5 March 2024

Re: Rasp Mine MOD11 - Response to Request for Information (RFI-67850207) further information regarding Ground Water Impact Assessment and report (further to previous RFI-65010208)

Subject: Rasp Mine Modification 11 - Groundwater drawdown assessment

Figure 2.1 Proposed workings sectioned by tunnel elevation

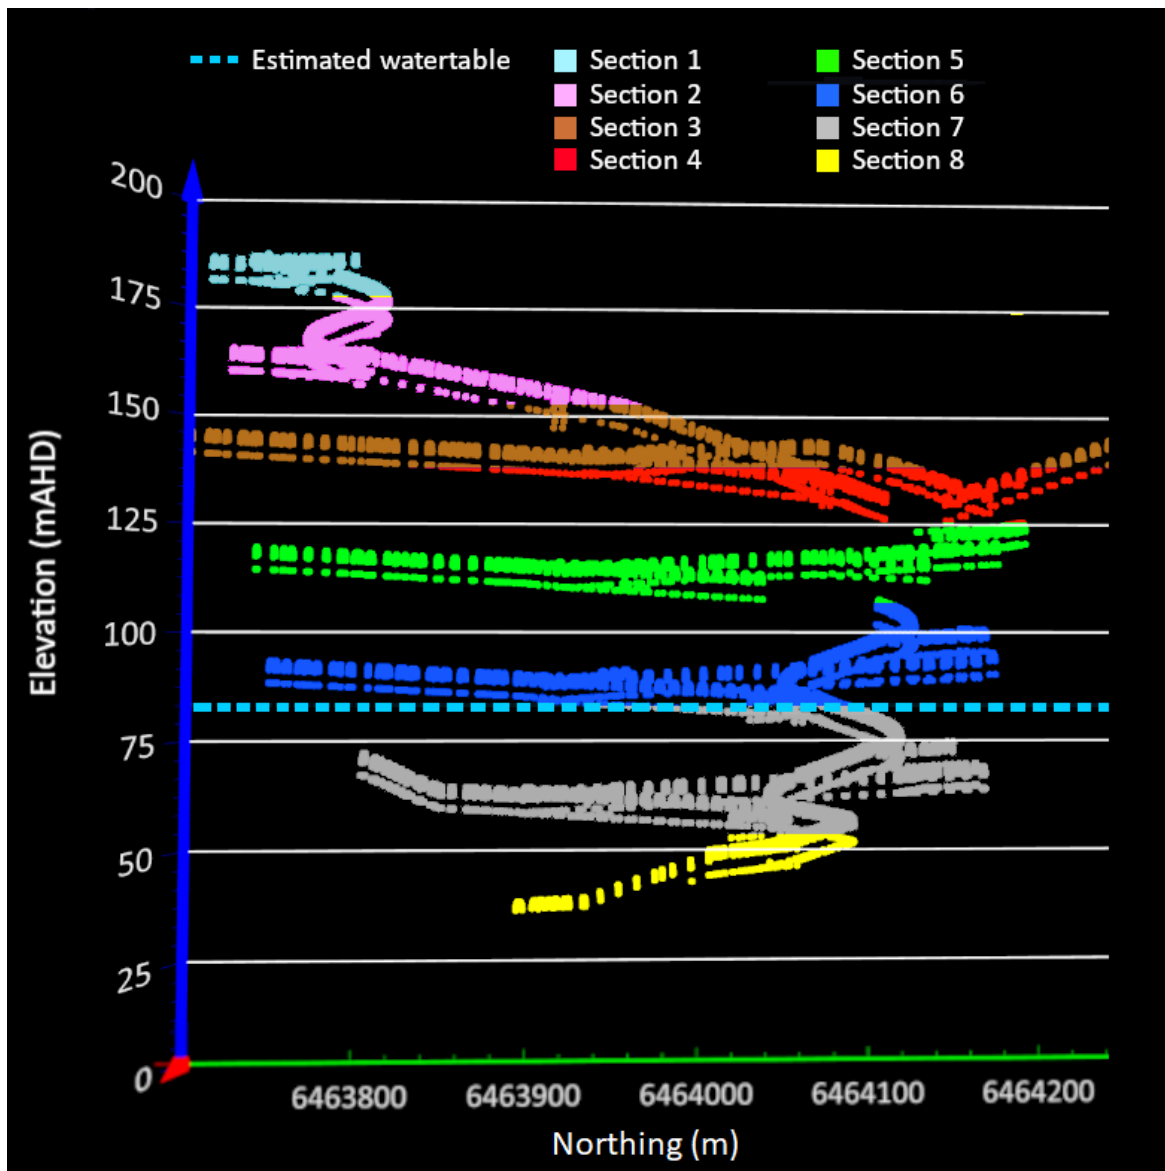
Figure 2.1 from the EMM consulting memorandum 31 January 2024

Section 2.4 – groundwater inflow to the mine workings: This section describes Section 6 of the new workings as being above the regional water table (assumed to be 85 m AHD) and that the average centreline is 89 m AHD (i.e. above the regional water table at 85 m). However, Figure 2.1 shows it to be below the regional water table and that deepest is down to 40 m AHD whereas it appears deeper for Section 8. Clarify about these matters and provide a revised Figure to reflect the information in Table 2.2.

Figure 2.1 was a 3D image that did not present clearly. The figure has been converted to a 2D image that is clearer and easier to understand. The figure has been updated in the EMM consulting memorandum and the memorandum reissued at 22 February 2024 (enclosed as Appendix A)

Appendix B – Section view (looking mine west) of the Rasp Mine workings, Thompson’s shaft location and Historic 1480 drive.

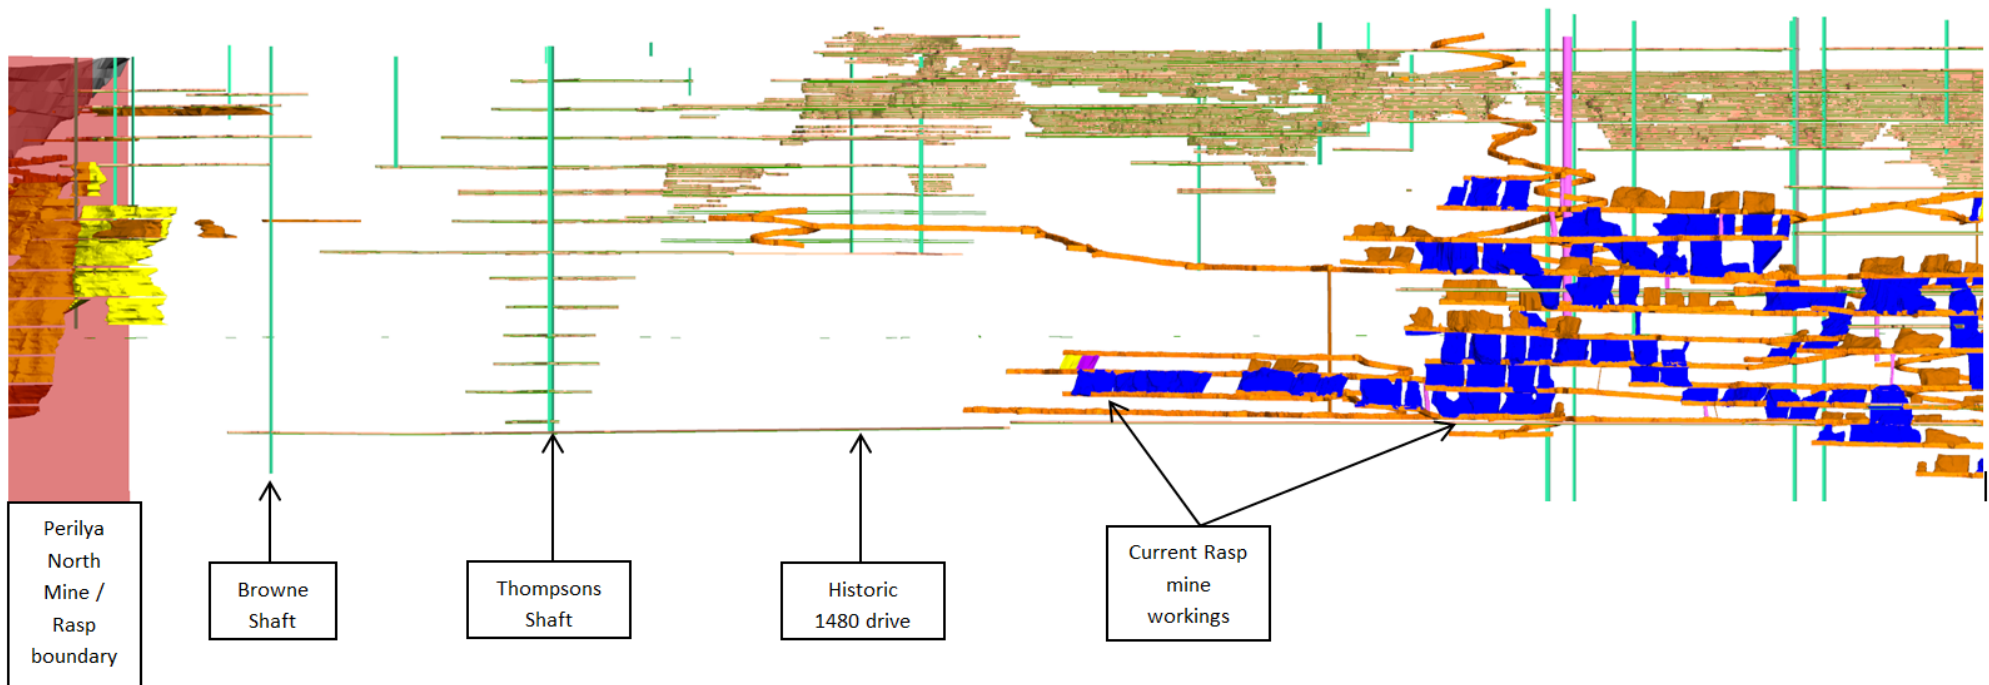
Section 2.2 - Thompsons Shaft: provide information about depth reading of its water level depth. The available information in section 2.2 about Thompson's Shaft (which is right next to workings) is noted: being dry to 85 mAHD (225m bgl) but its depth goes down to 480 mbgl and that if water level is below 40 m AHD (270 mbgl) it will be below or at proposed additional mine development and therefore as the regional groundwater is already dewatered then there would be no incremental impact.

Appendix B – Section view (looking south) of the Rasp Mine workings, Thompson's shaft location and Historic 1480 drive (1480 ft. below ground level) shows the connection of Thompsons shaft to the historic 1480 drive. The 1480 drive extends across the entirety of the Line of Lode from the Perilya North Mine, through the Rasp Mine and to the Perilya South Mine. The 1480 drive is currently dry (observation from the Rasp Mine), no flows of water are visible along this drive that connects to current Rasp Mine workings. As a result it is evident that the Thompsons shaft is dry to 480mbgl.
